STATE	PROJECT DESIGNATION	YEAR	SHEET NO.	TOTAL SHEETS
ALASKA	BRF-037-2(19)	1971	63	74

AS BUILT PLANS

NENANA RIVER BRIDGE
AT PARK BOUNDARY
Route No. F-37
GENERAL LAYOUT

BRIDGE NO. 694
DWG. NO. 2390

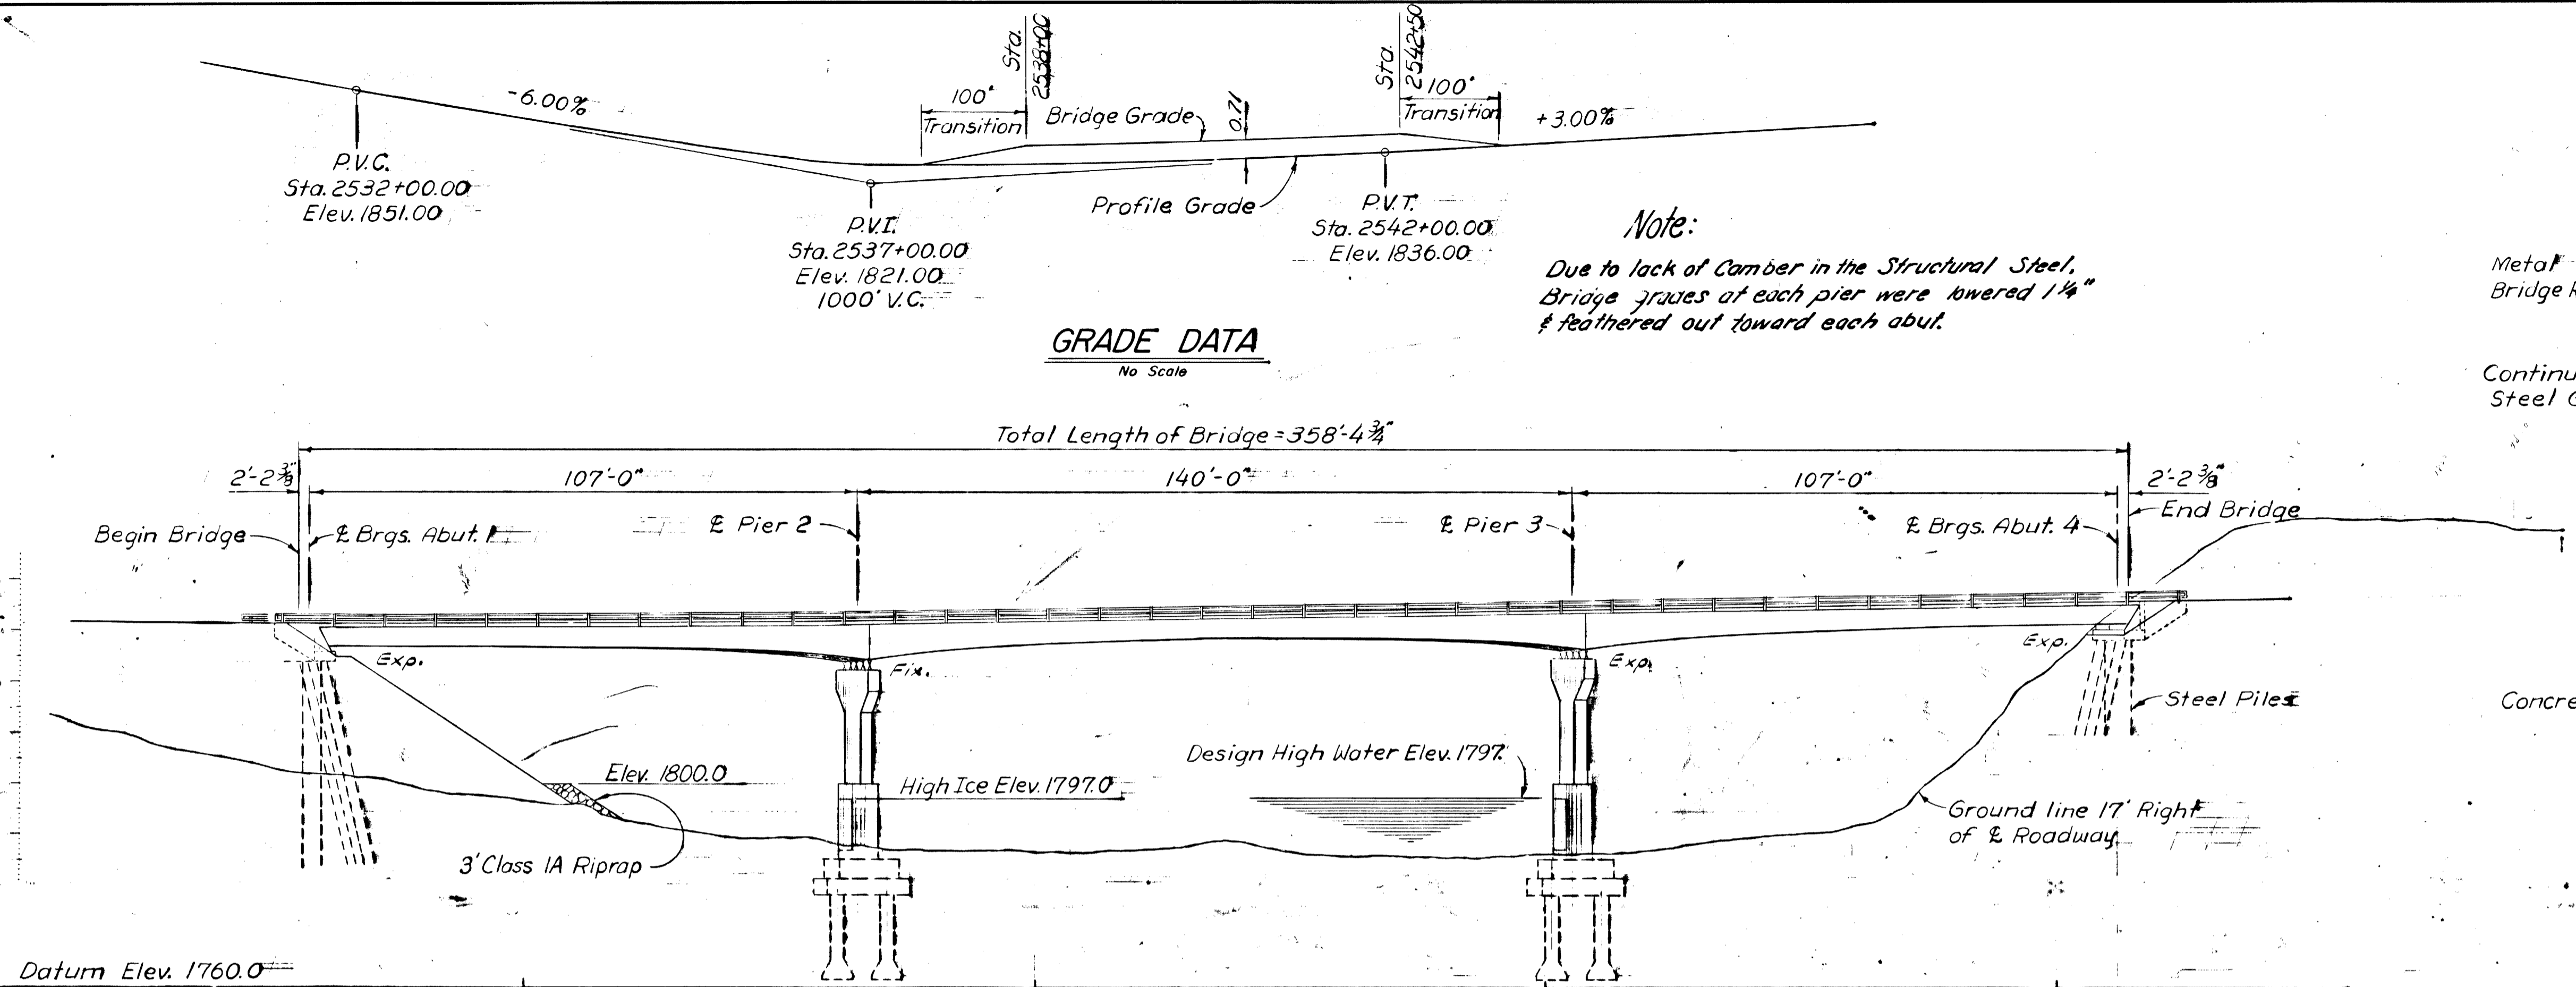
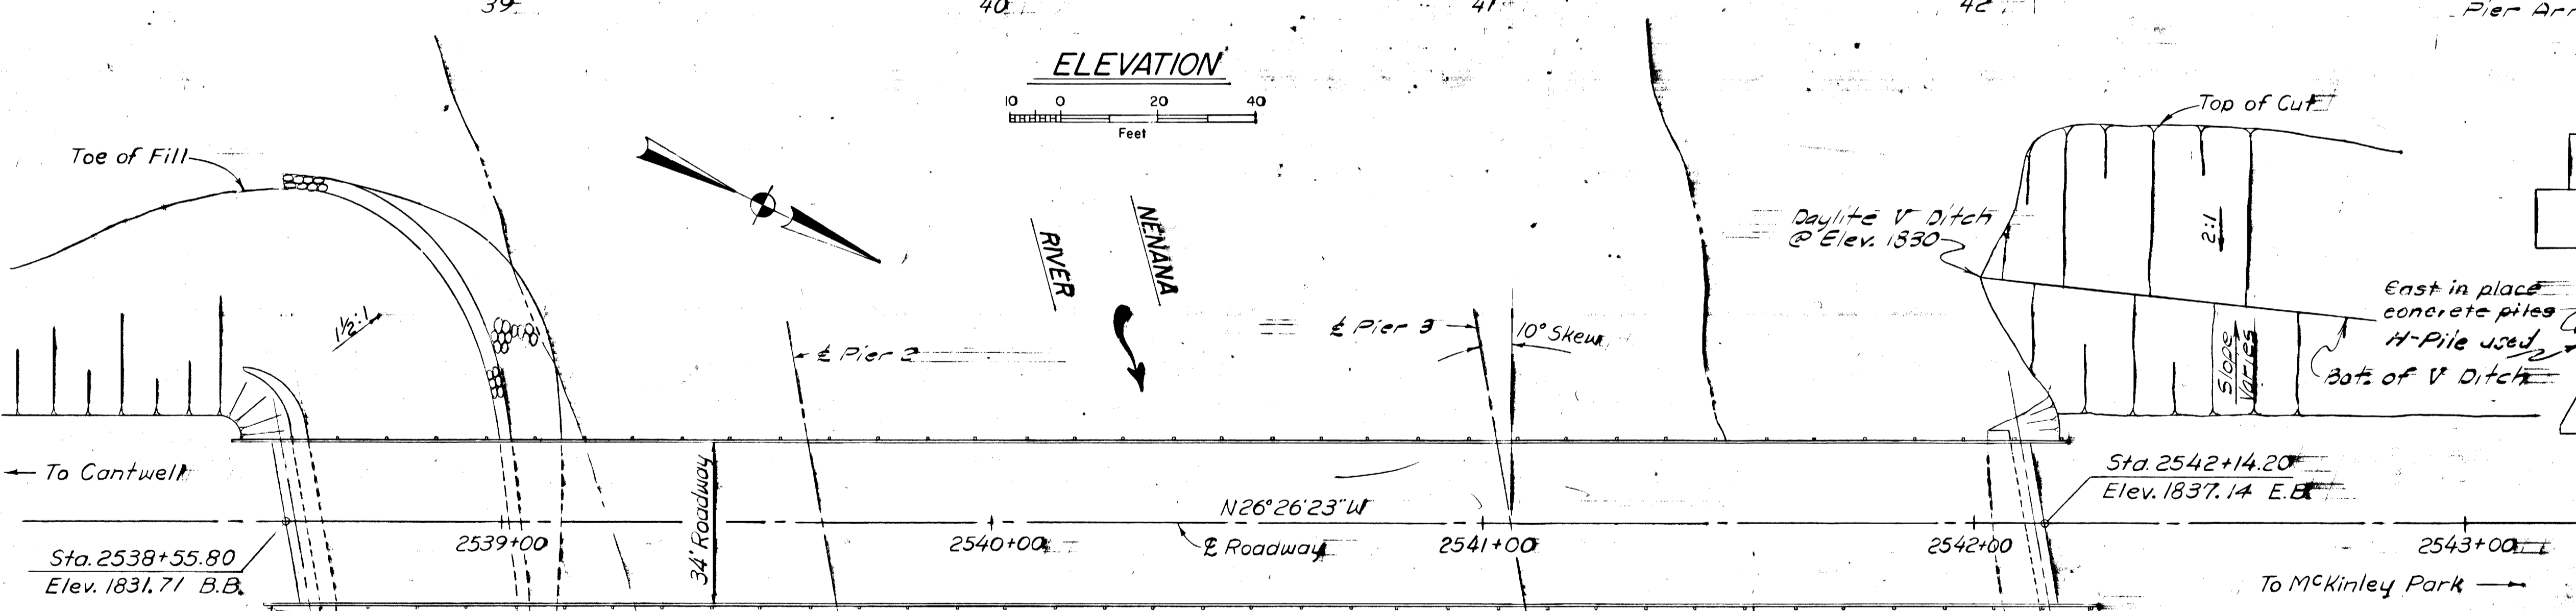
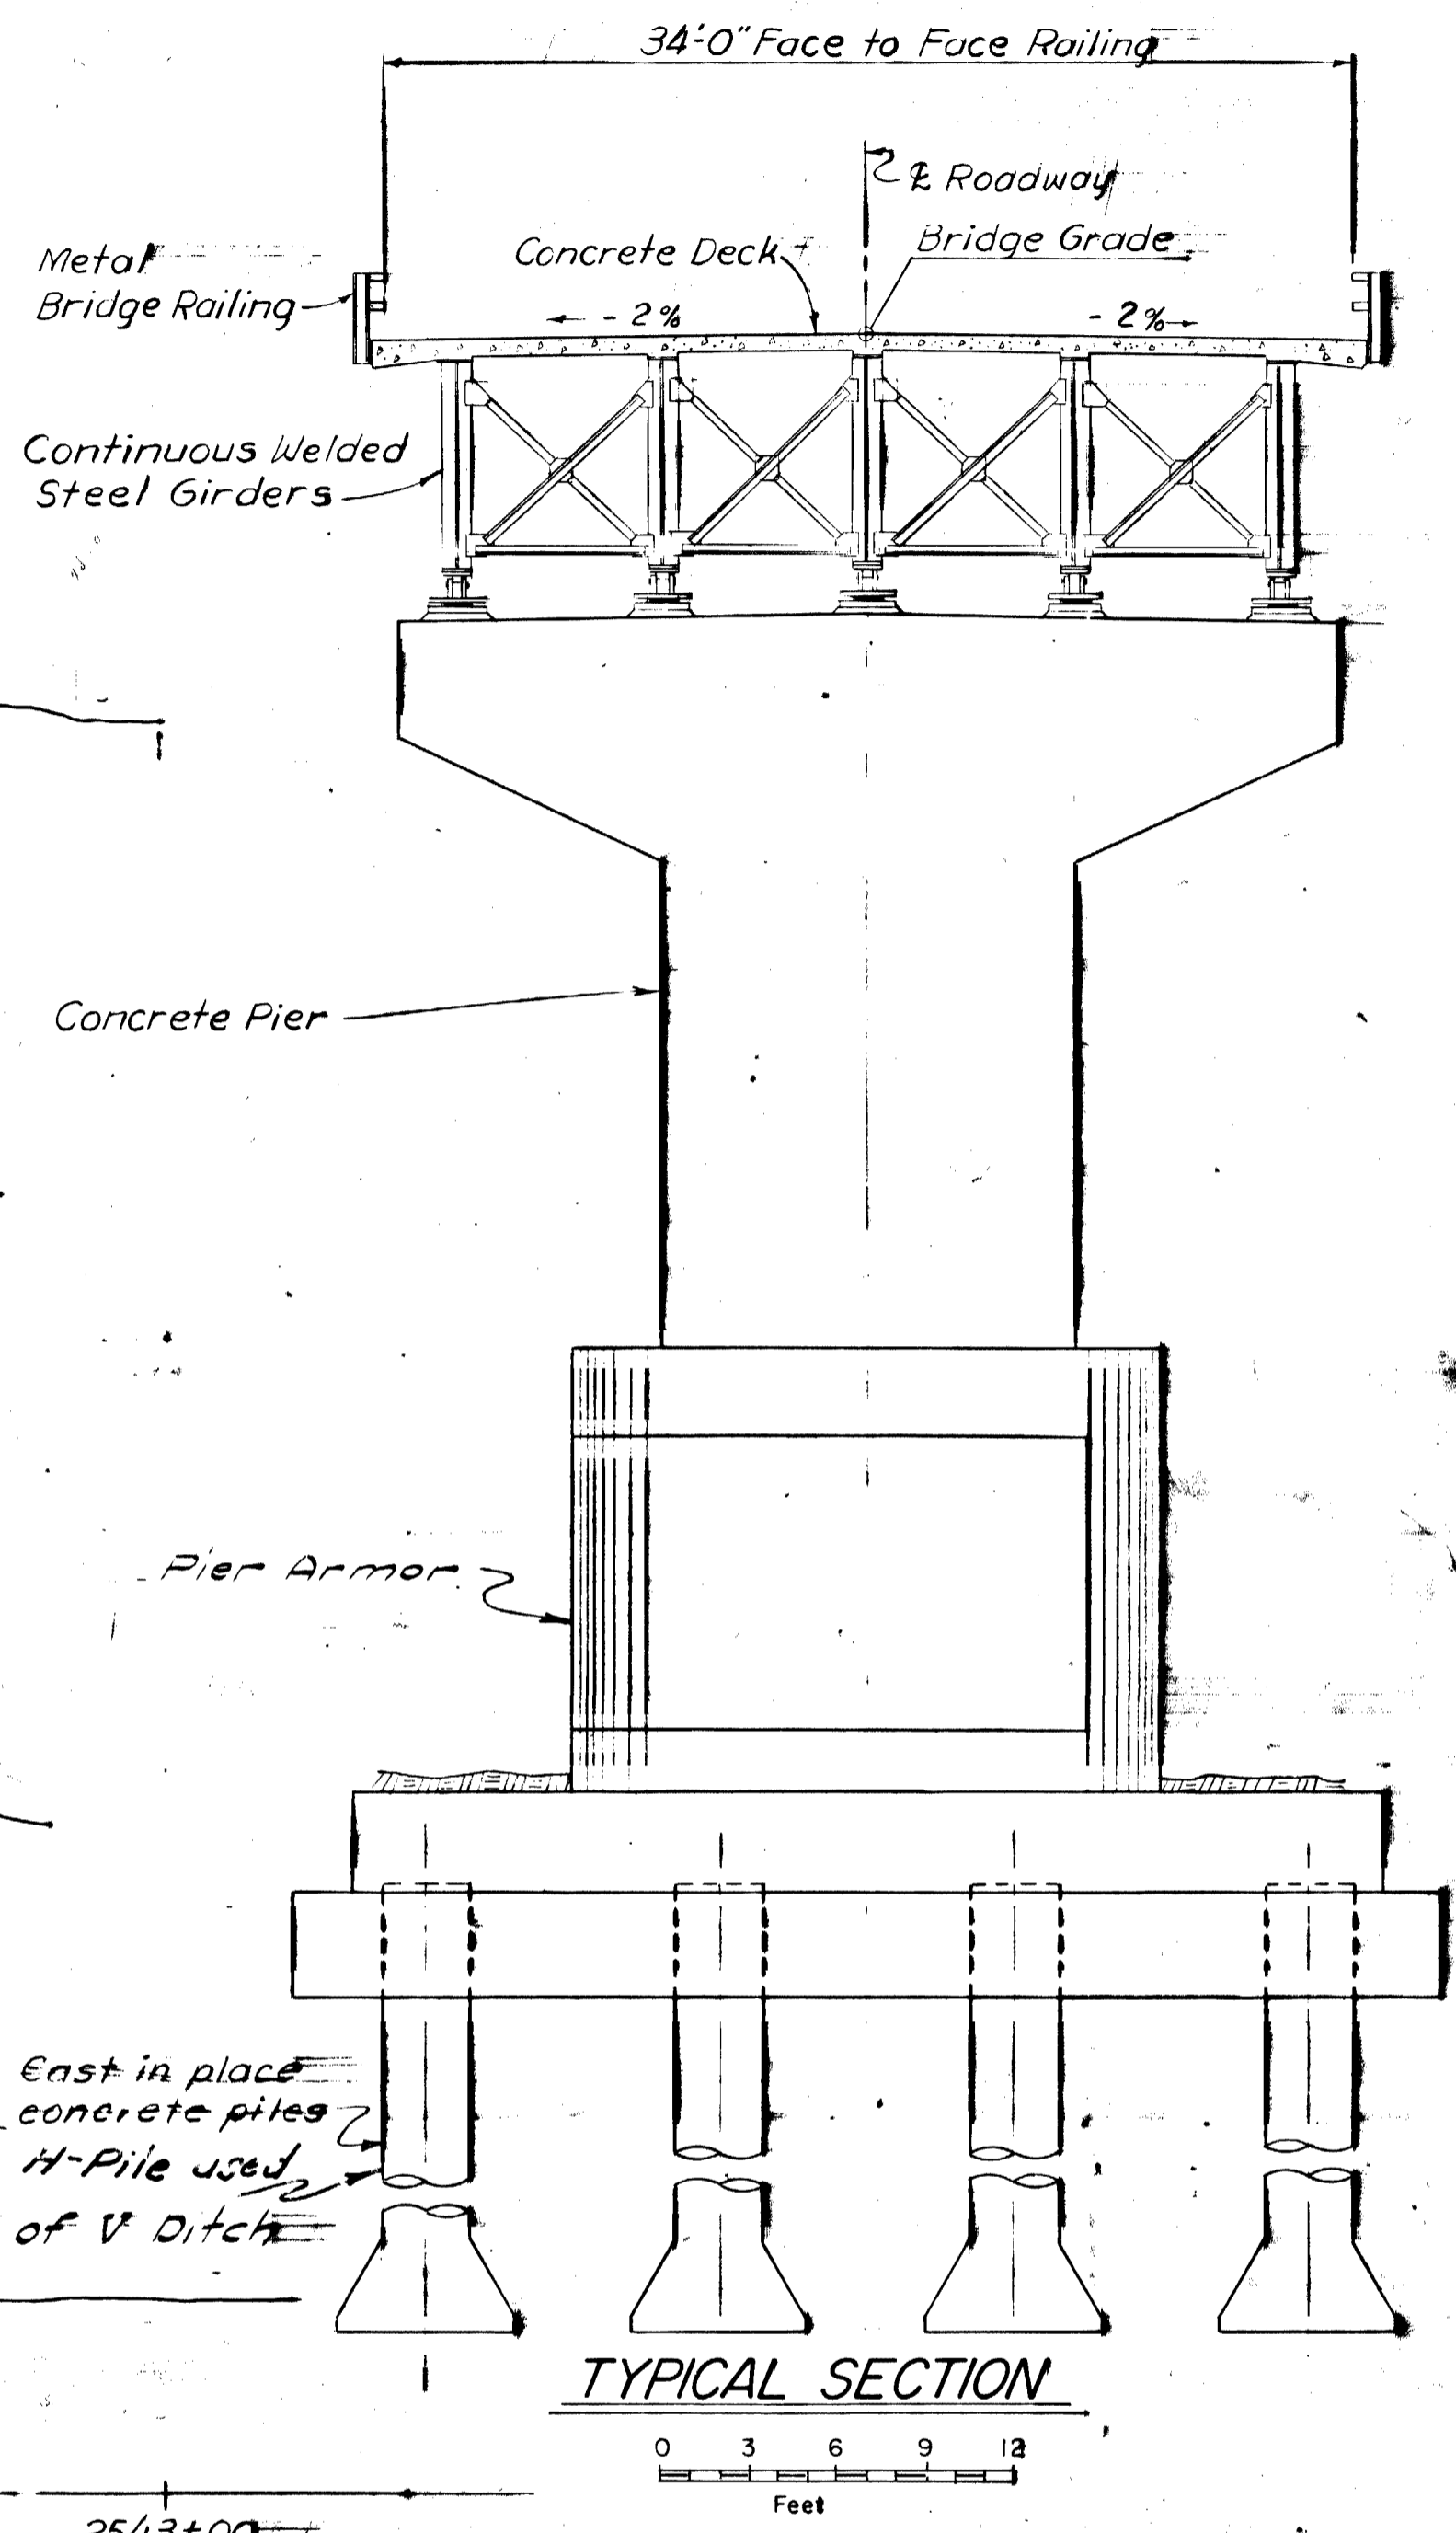
Note:
Due to lack of Camber in the Structural Steel, Bridge grades at each pier were lowered 1/4" & feathered out toward each abut.
